From the Planning Department, submitting the Responses to Comments (RTC) on the Draft Environmental Impact Report (DEIR) for 3333 California Street Mixed-Use Project. File Nos. 190844 & 190845. Copy: Each Supervisor. (1)

Responses to Comments (RTC) on Draft Environmental Impact Report (DEIR) for 3333 California Street Mixed-Use Project

DATE: August 22, 2019
TO: Angela Calvillo, Clerk of the Board of Supervisors
FROM: Kei Zushi, Senior Environmental Planner – Planning Department
 (415) 575-9038
RE: Responses to Comments (RTC) on DEIR for 3333 California Street Mixed-Use Project, Planning Department Case No. 2015-014028ENV
HEARING DATE: N/A

C2.02

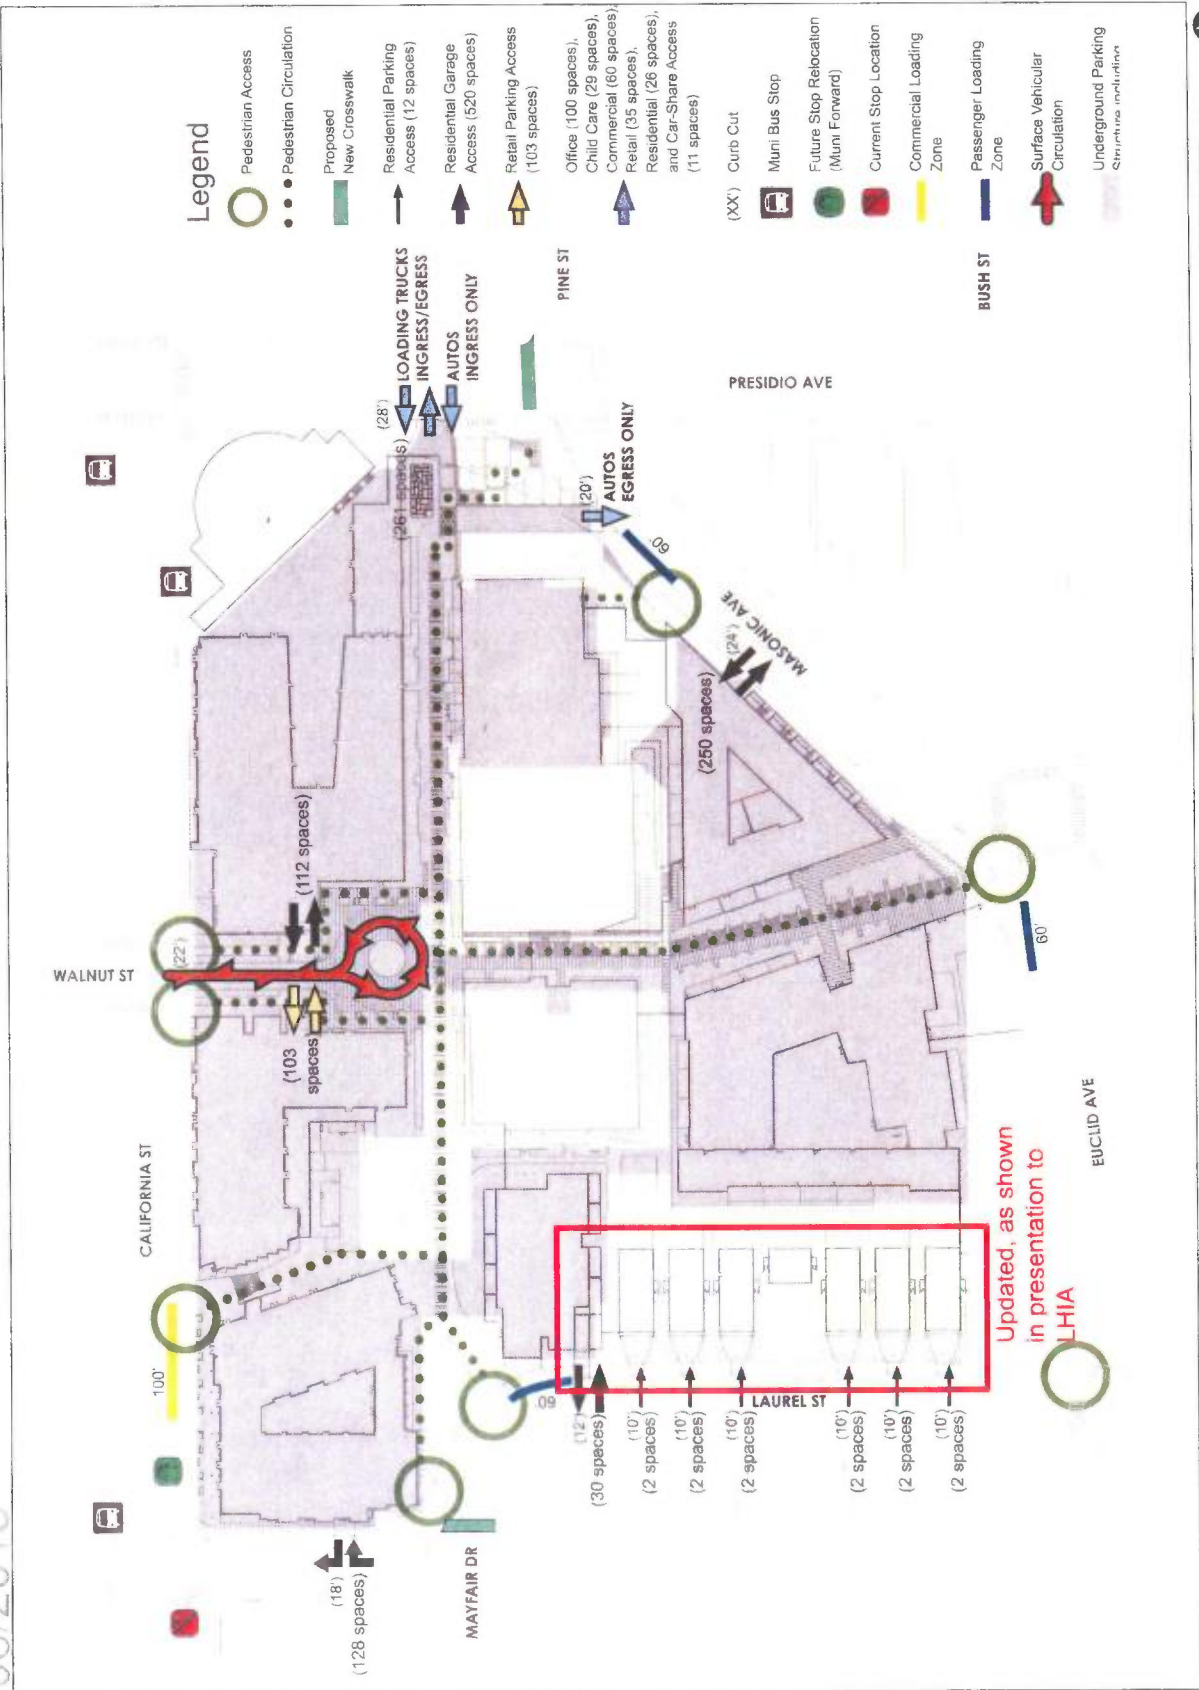
Sheet C2.02 shows a new proposed bulb-out would be installed adjacent to the right westbound traffic lane on Pine Street at the corner of Presidio Avenue and Pine Street. (Ex. L) Pine Street is a Major Arterial containing three one-way lanes of westbound travel. DEIR 4.C.5. During commute hours, traffic is very heavy on Pine Street westbound, with substantial vehicles traveling from downtown work locations. The proposed bulb-out at this location would cause traffic to slow down at the intersection of Pine Street and Presidio Avenue where visibility is already impaired due to the upward slope. Due to vehicles slowing down near this bulb-out, the proposed project would have increased risk of rear-end crashes or other hazards to vehicles traveling on this major artery and also could cause potential traffic back-ups which would also cause increased risk of collisions. The DEIR is inadequate for failing to analyze this potentially significant impact and mitigation measures that could reduce the impact to insignificance. The DEIR’s claim that the project’s proposed streetscape changes, including bulbouts, would not increase the risk of rear-end crashes or other hazards is conclusory and not supported by substantial evidence. The following mitigation measure would mitigate this impact to insignificance:

MITIGATION MEASURE: Eliminate the proposed bulb-out at the intersection of Pine Street and Presidio Avenue as shown in plan sheet C2.02.

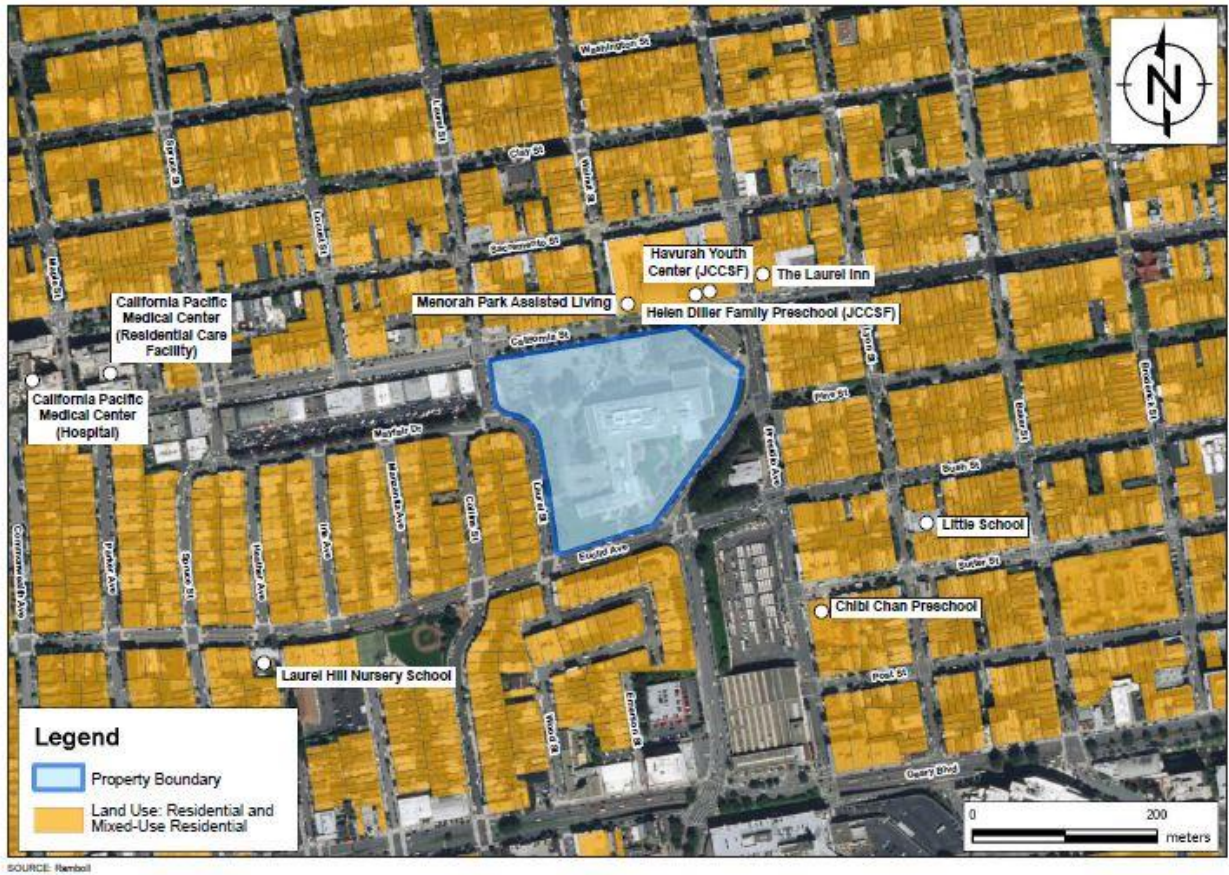
“The young children attending this pre-school would appear to be sensitive receptors. Why is the 150 Parker Avenue School not shown on the map (Page 4.E.30) below?” (*Rose Hillson, Letter, January 8, 2019 [I-Hillson2-43]*) [Figure 4.E.2 referenced on p. 23 in Comment Letter I-Hillson2 is shown on EIR p. 4.E.30 and in RTC Attachment B.]

Page 4.E.30: The map of the Sensitive Receptors has the legend covering up the 150 Parker School that is just as distant as the CPMC sensitive receptor yet it is not shown on the map nor mentioned in the list of sensitive receptors on Page 4.E.17.

The One Fifty Parker Avenue School was not included in EIR Figure 4.E.2. This figure has been revised to show this location as a sensitive land use; this revision does not affect the analysis or any results. As discussed on EIR pp. 4.E.17-4.E.18 and in Response AQ-1, pp. 5.G.3-5.G.11, all sensitive receptors shown on Figure 4.E.2 and Figure 4.E.7 such as daycare centers and hospitals were evaluated as residential land uses as a conservative assumption because residences would have longer exposure durations (compared to daycare centers and other non-residential sensitive land uses), and would therefore be expected to have greater health impacts. This is true for the One Fifty Parker Avenue School, which is over 1,000 feet west of the project site. As such, including this school on Figure 4.E.2 does not affect the location where the proposed project or project variant would have the maximum impact. See Figure 4.E.8, EIR p. 4.E.57, for the locations of the off-site and on-site maximally exposed individual sensitive receptors locations.

Figure 4.E.2, on EIR p. 4.E.30, has been revised to include a label for the One Fifty Parker Avenue School site. The revised figure is shown on the following page.
